ZBA 2022-29

Petition of Bank of America, NA  
342 Washington Street

#### ZBA 2022-29 BANK OF AMERICA, 342 WASHINGTON STREET

Subject: Bank of America Wellesley  
**Construction Change Narrative Letter**  
Project Number: 005.3722.000  
File Code: 5CD

## PROPOSED WINDOW REPLACEMENT DETAILS

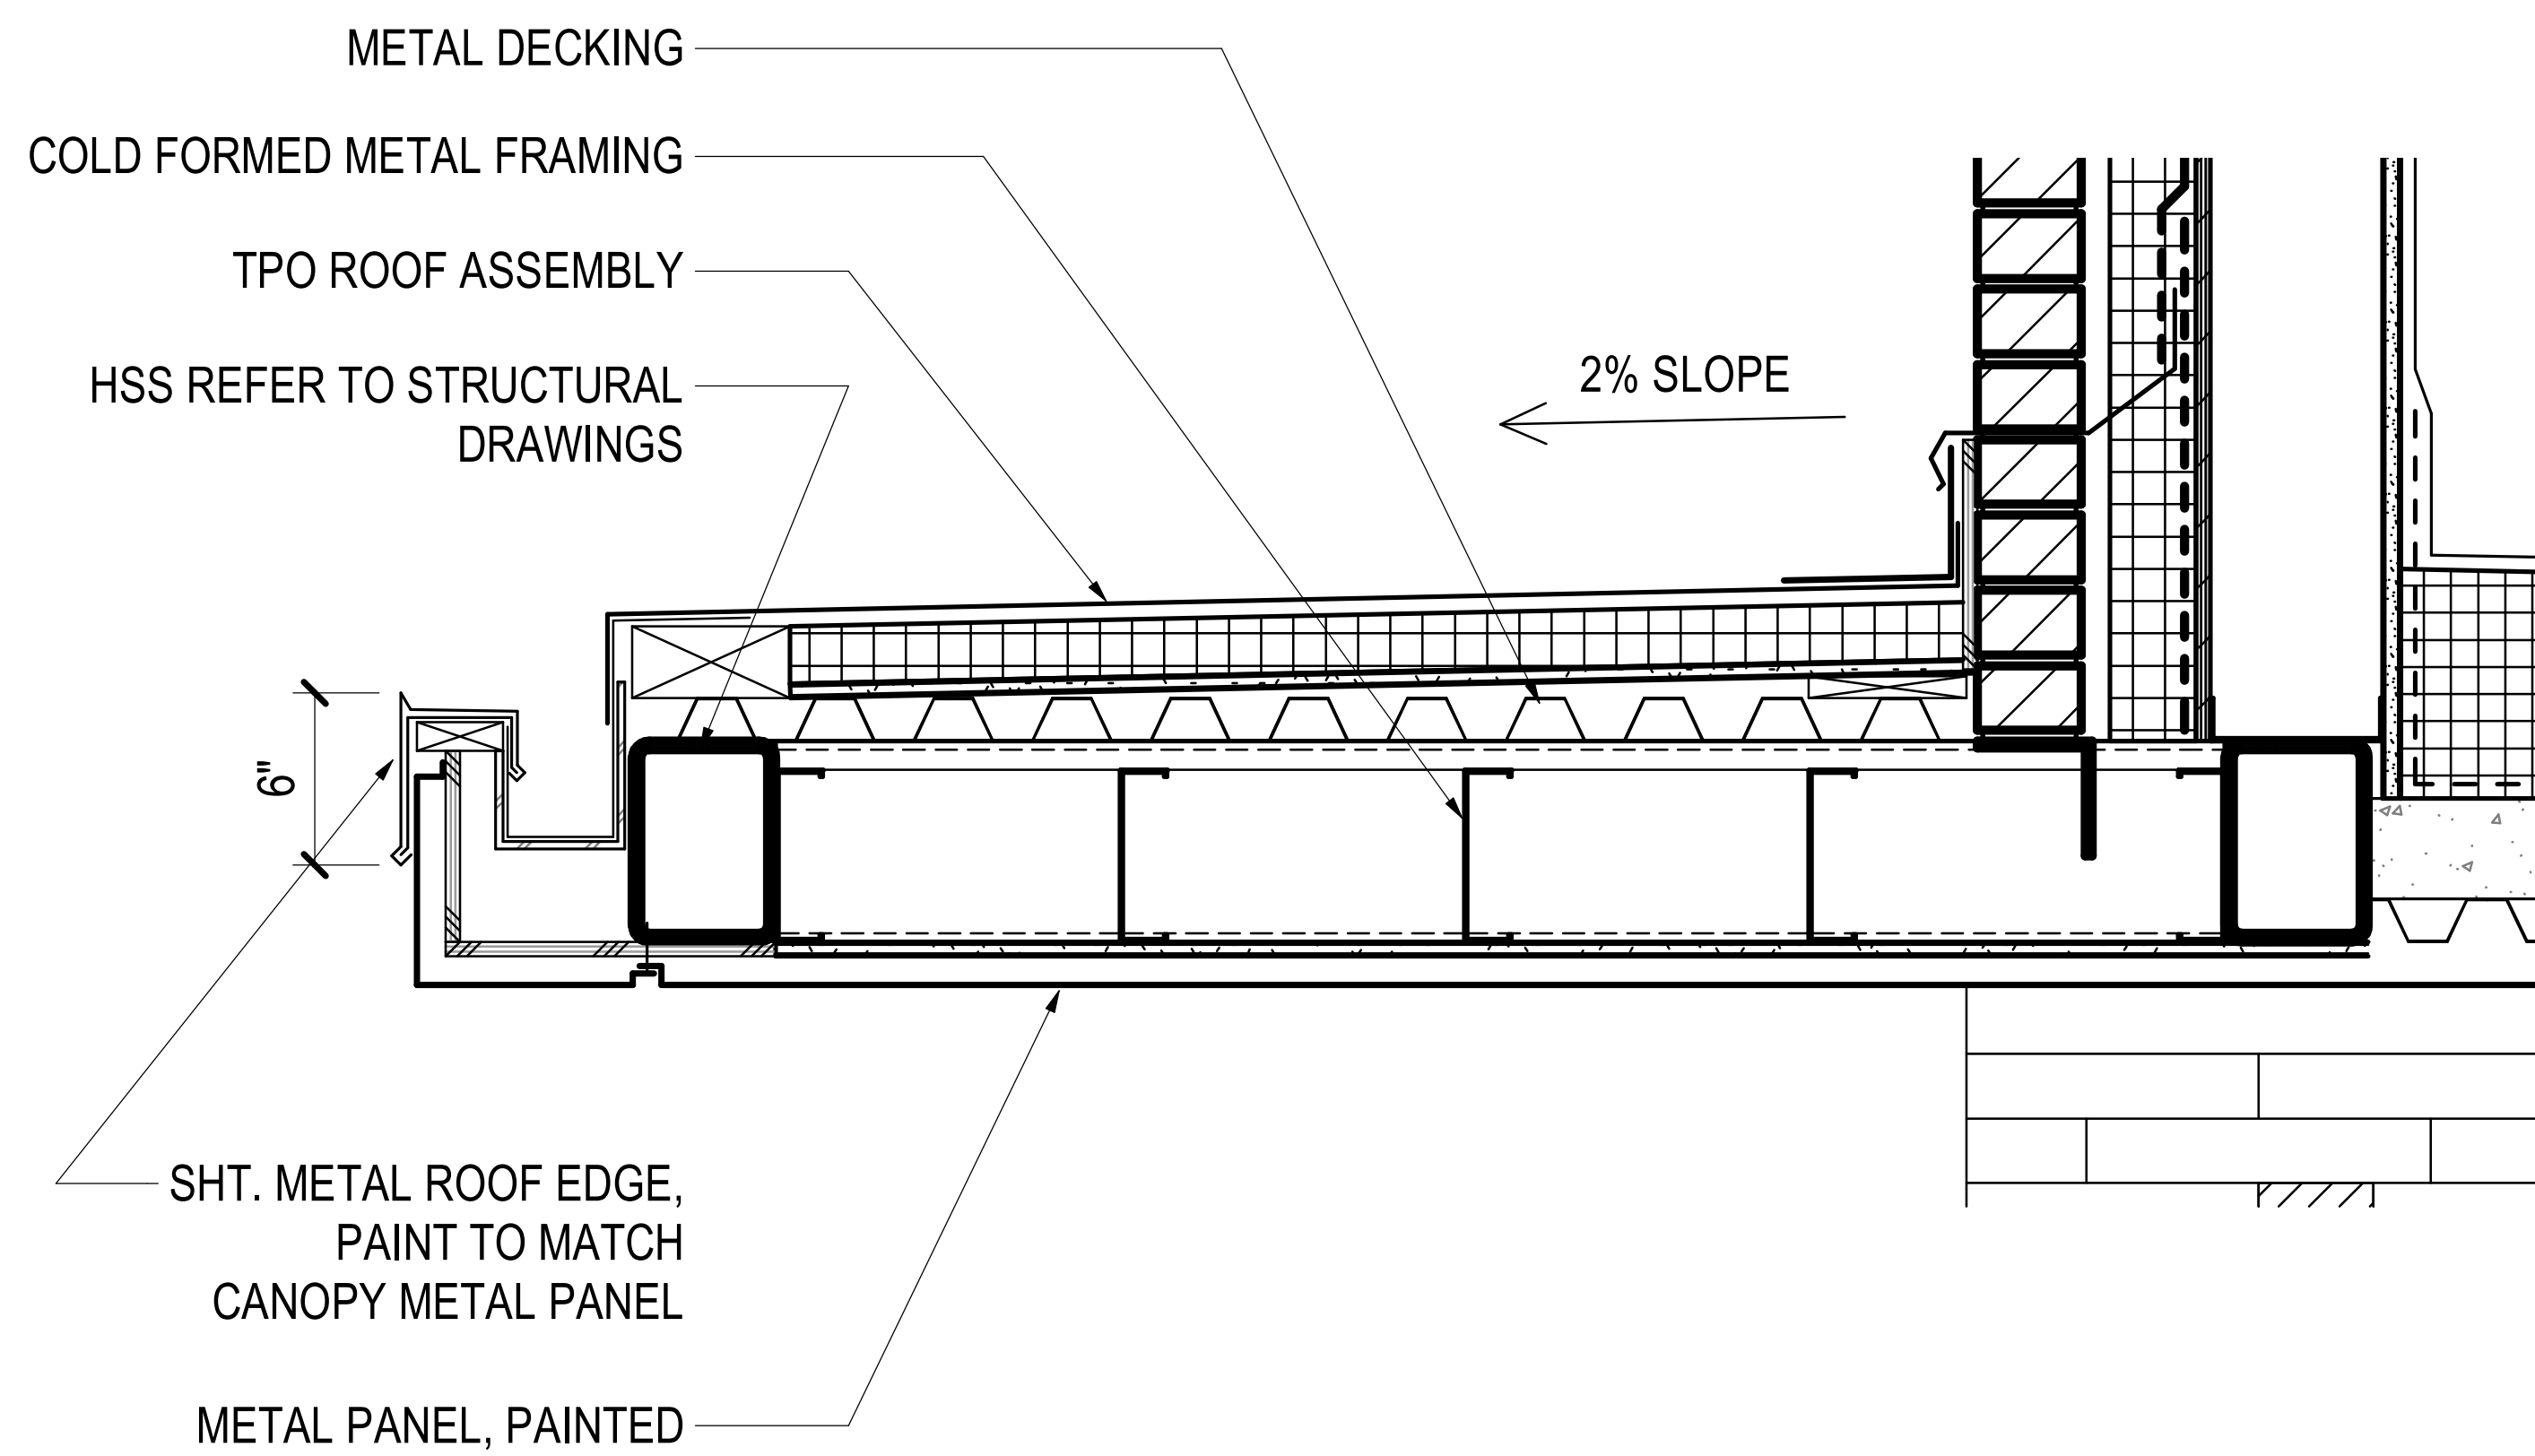
Ms. Reker said that the existing large composite windows suffered a lot of water and insect damage. She said that they will replace them with matching windows with the same detail and color. She said that the existing windows will not survive the construction process. Mr. Adams said that the new windows in the existing building will look like the old ones but will be made of slightly different materials. He said that the new addition behind the existing building facing Washington Street will have windows of a similar size but are more modern looking.

1. **Replace four (4) large existing windows on south and north façade of the building** – these four existing windows are showing evidence of water leaking and insect damage. See Appendix 'A' for existing window conditions. Gensler proposing to replace the window with Kawneer curtain wall system. The curtain wall system can work with snap trim pieces that closely resemble the existing window trim. For further details, please refer to page AR-09 in the presentation deck.

### CANOPY SECTION - TPO ROOFING

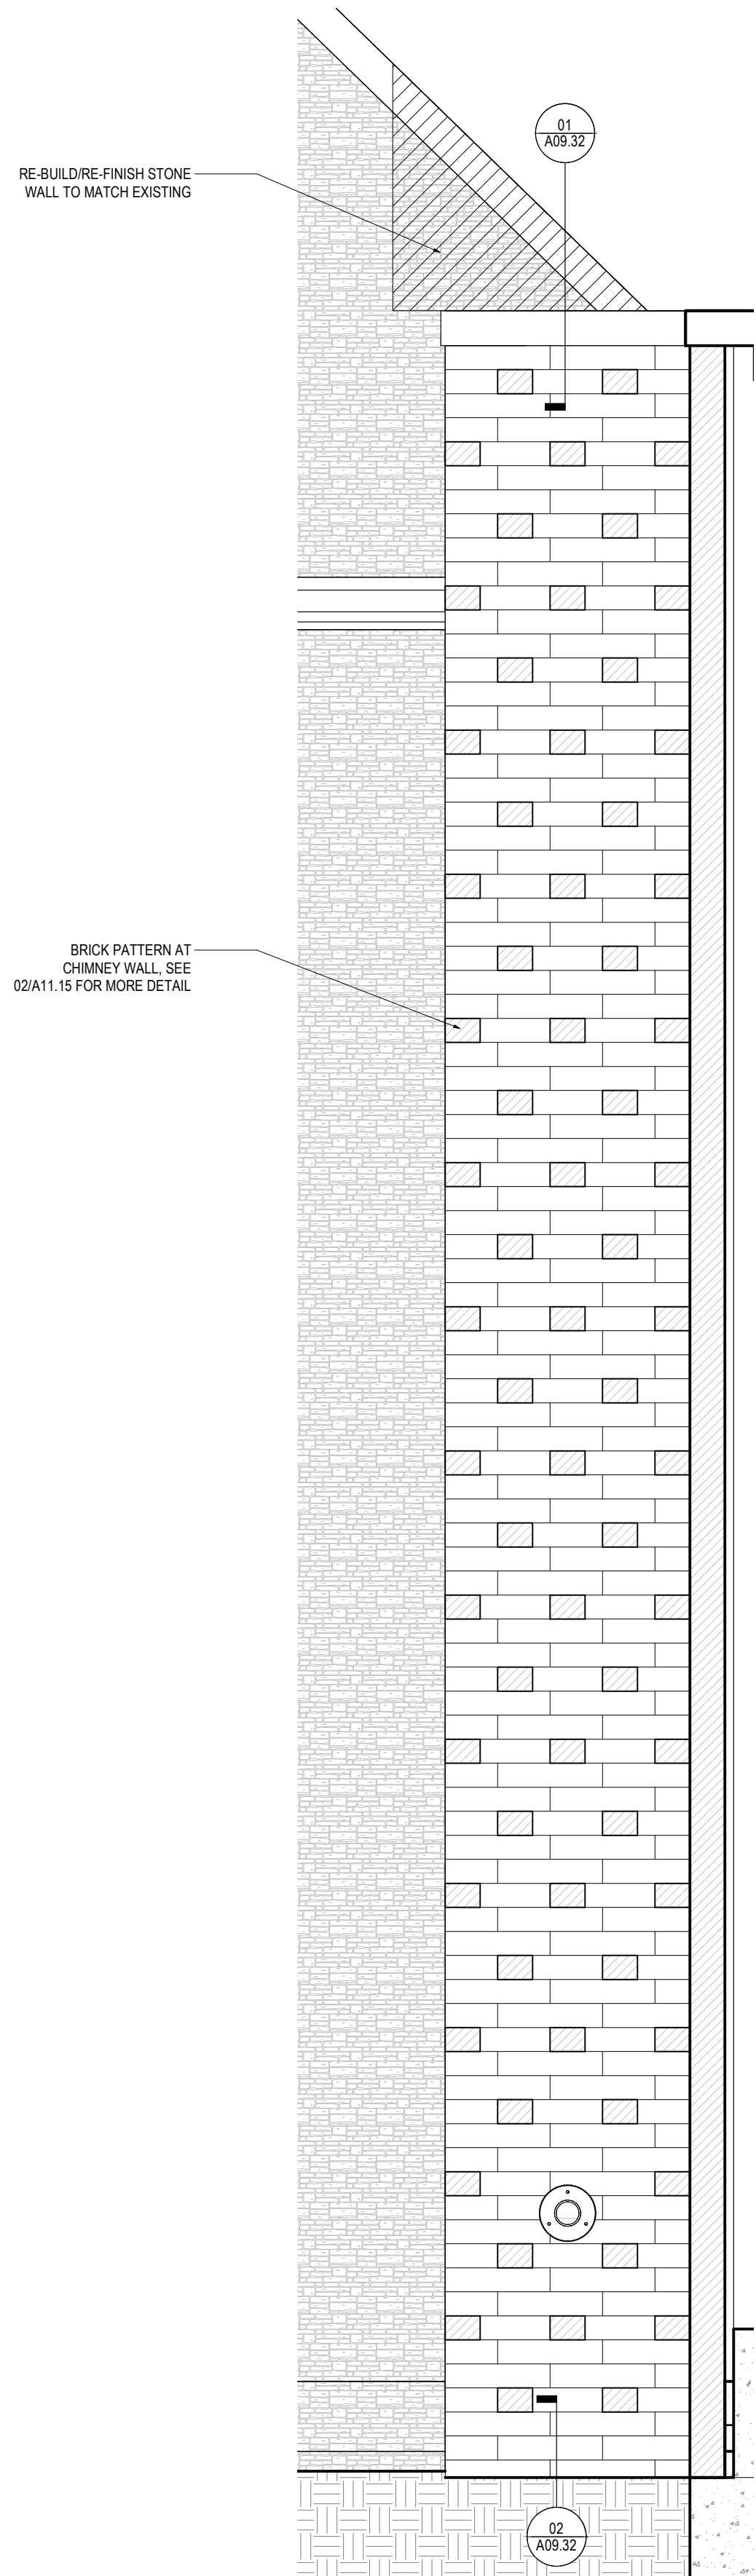
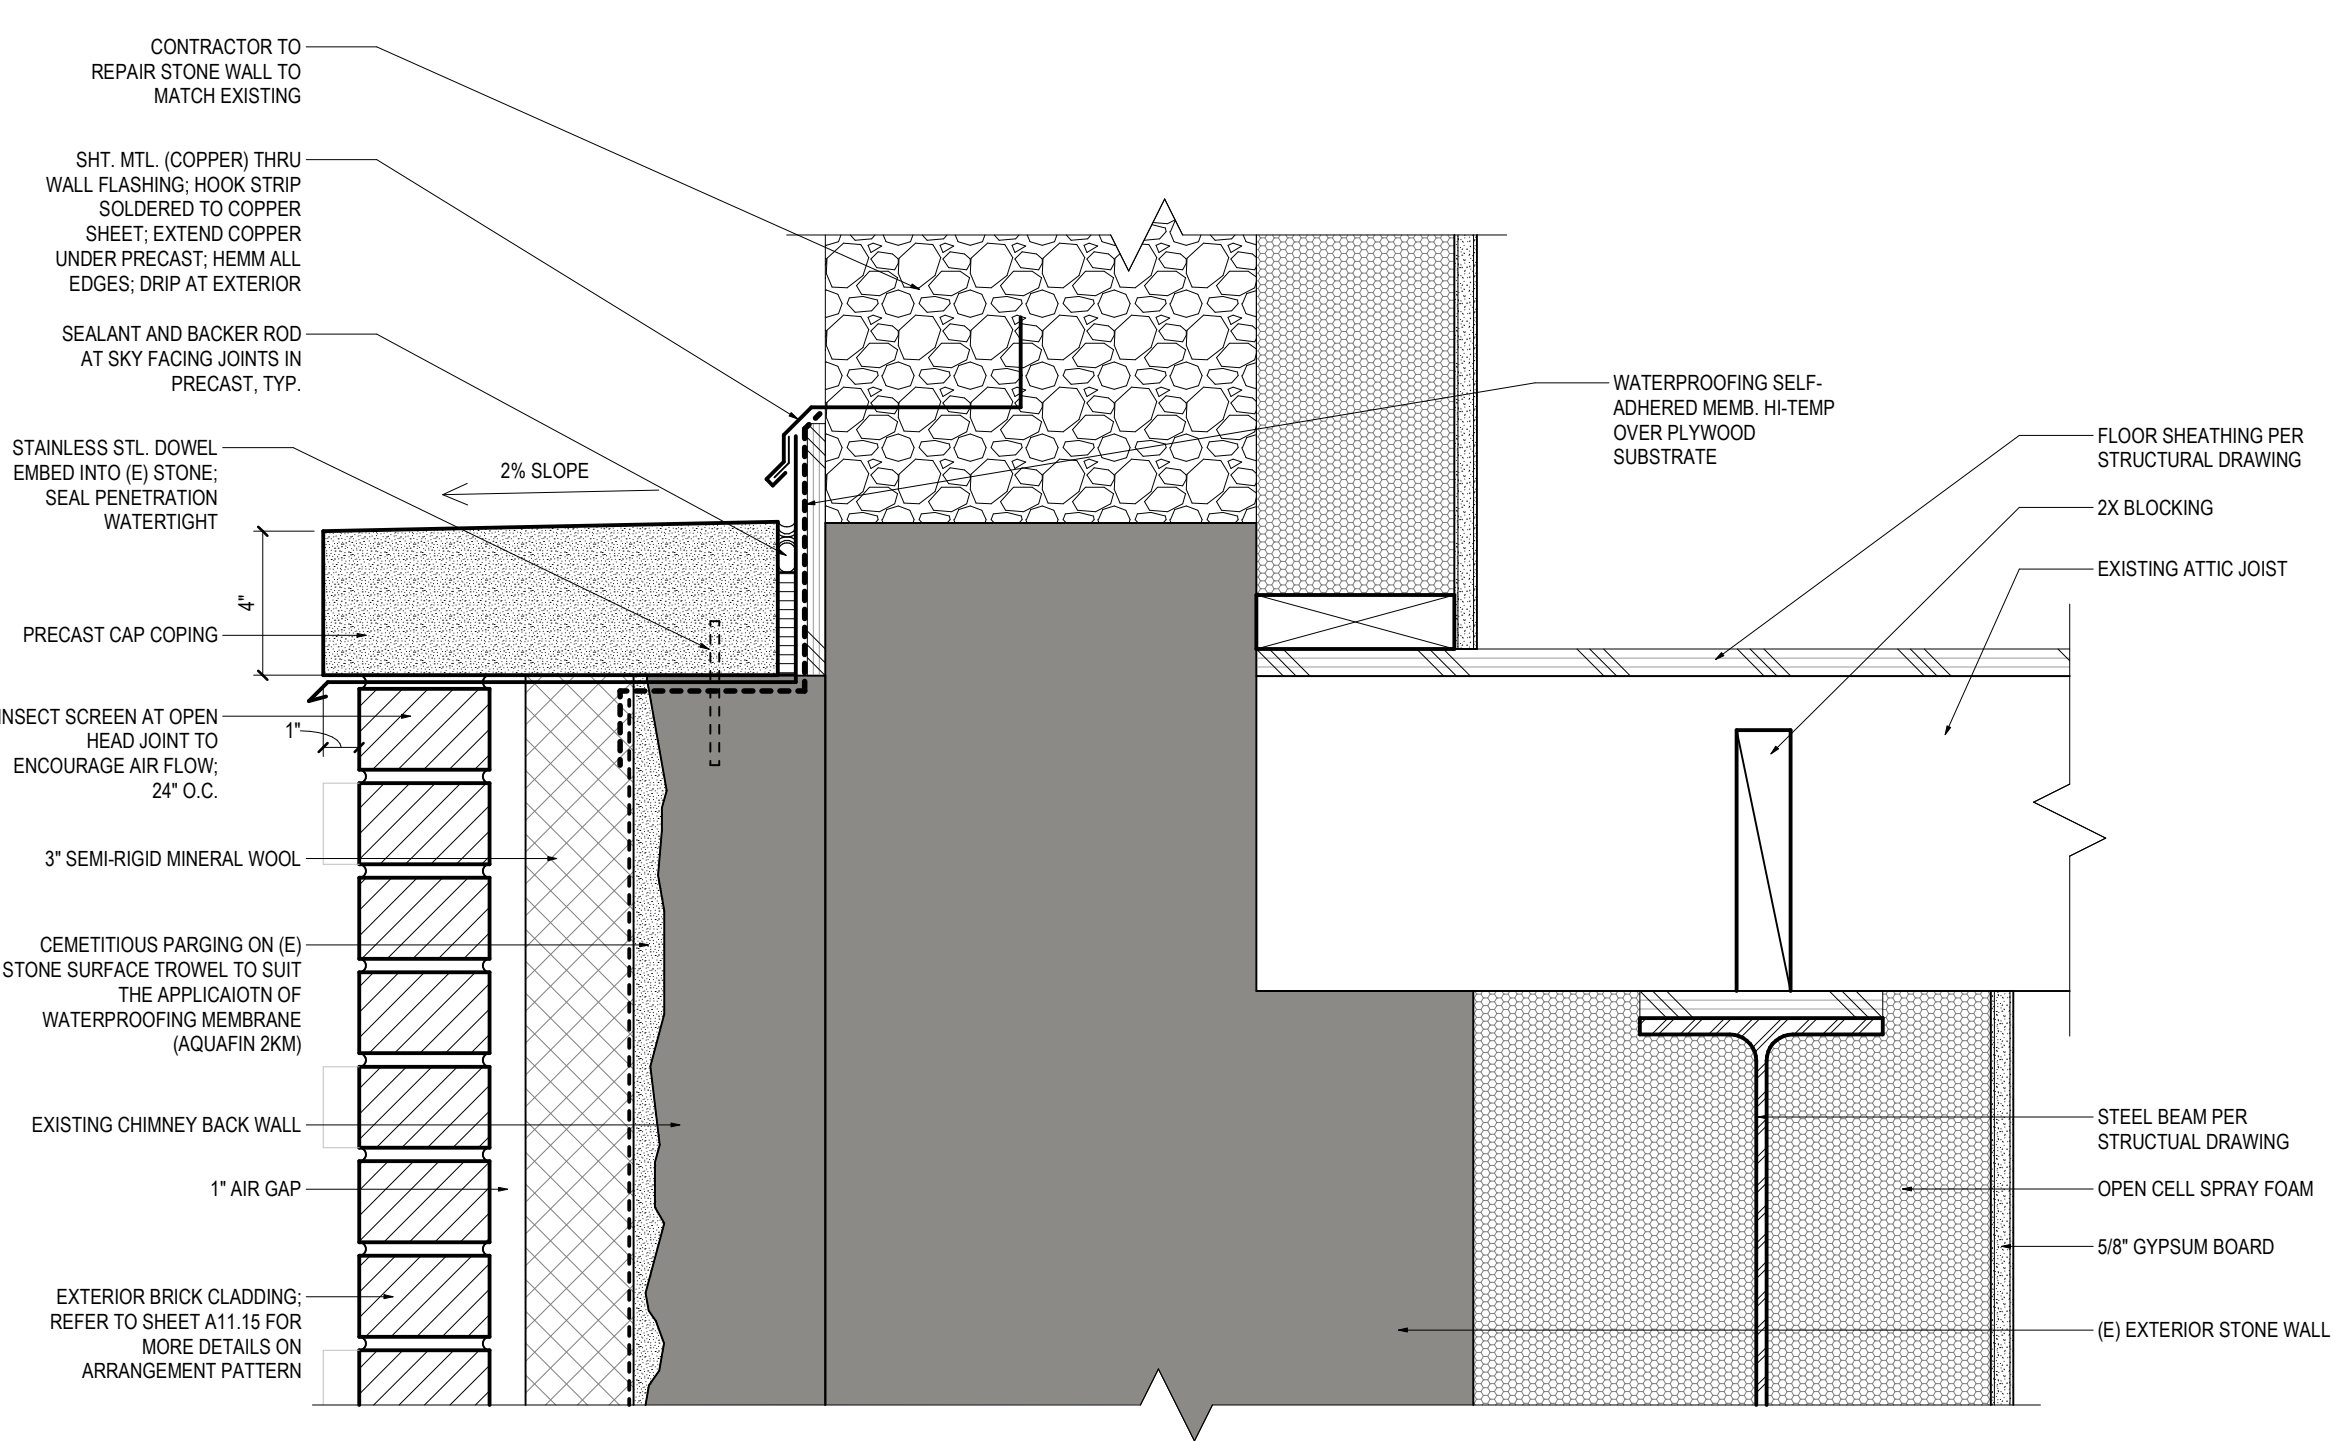
Julie Reker said that three components are being adjusted. She said that there are two small roof canopies where they will change the material on the top from metal to TPO, which is a rolled goods material. She said that the proposed change is to the canopy over the ATM at the back, which is a small area that sticks out approximately three to four feet. She said that there is an employee only side entrance where they will

add a small canopy. She said that canopy, when viewed from Washington Street, is on the right side about half way back. Mr. Adams said that the canopies are shown on Plan AR-03C. Mr. Levy confirmed that the structure will stay the same and that the only change is to the materials on top of the roof surface of the canopies. Ms. Reker said that the front edge will still be metal, so you will not see that there is a different material on the top.

2. **Change top of canopy from metal panel to TPO roofing membrane** – Considering our budget constraints, we propose replacing the metal panel on top of the canopies with TPO roofing membrane. Although the TPO membrane is of a lighter color, due to the angle and height of the canopies, pedestrians will not have a clear visual of the lighter TPO membrane. To get a better understanding, please refer to the rendering provided on page AR-03B and AR-03E in the presentation deck.
